**From:** Laura Gibbons <Laura.Gibbons@arun.gov.uk>  
**Sent:** 16 October 2019 11:19  
**To:** Ben Whitby [REDACTED]  
**Cc:** Daniel Vick <Daniel.Vick@arun.gov.uk>  
**Subject:** RE: Clifton Road,Bognor Regis,West Sussex- Surface Drainage

## Surface Water Drainage Proposal Checklist

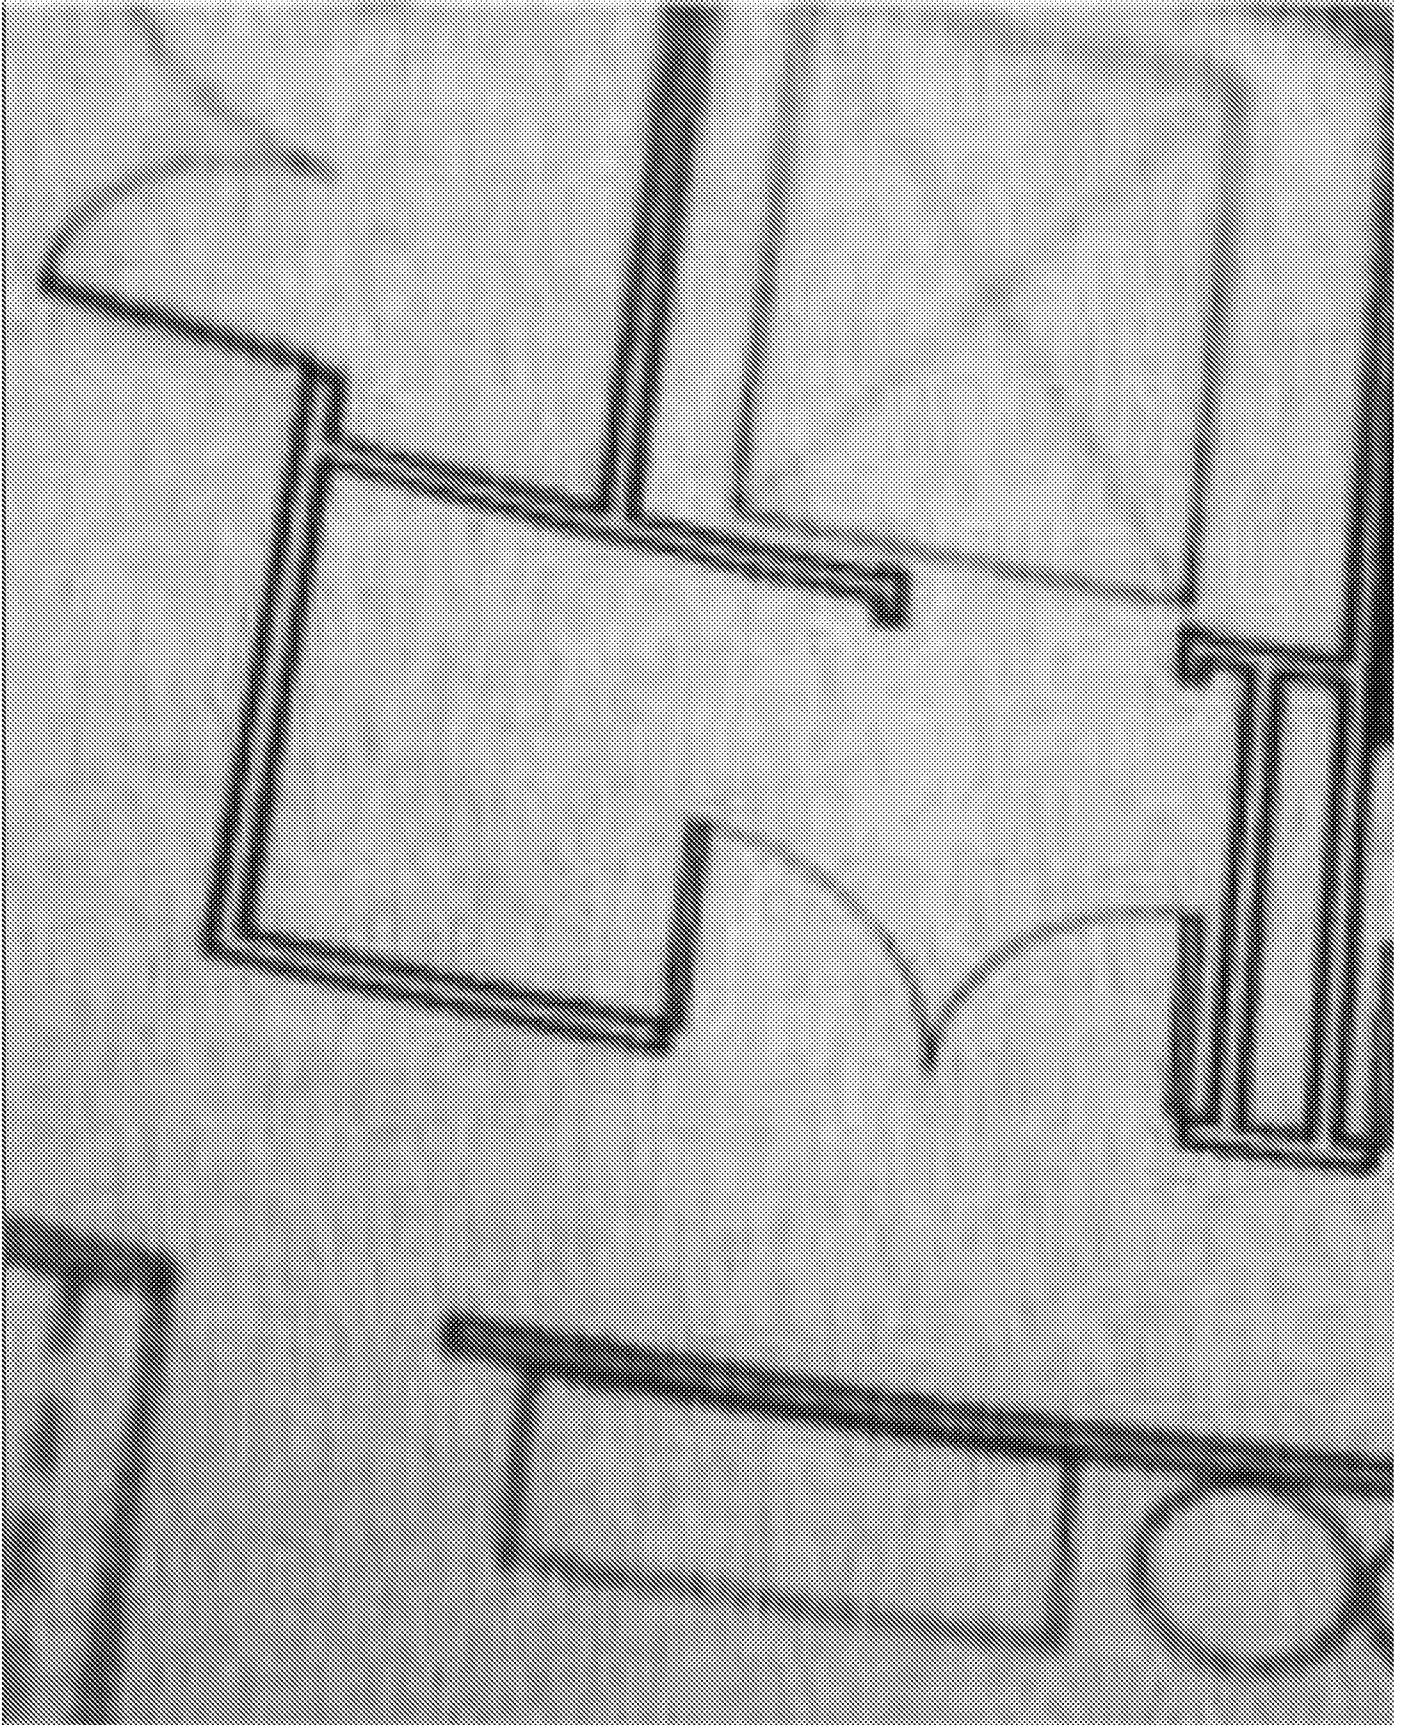
surface has been discharged into new soakaway, not into existing.

The two existing soakaways were dug out and mass filled with concrete.

Please see attached photos from our ground worker Glen Oakley. All approved by building control etc.

We require winter groundwater monitoring results and winter infiltration testing results to be supplied along with calculations evidencing that the soakaway is an appropriate size.
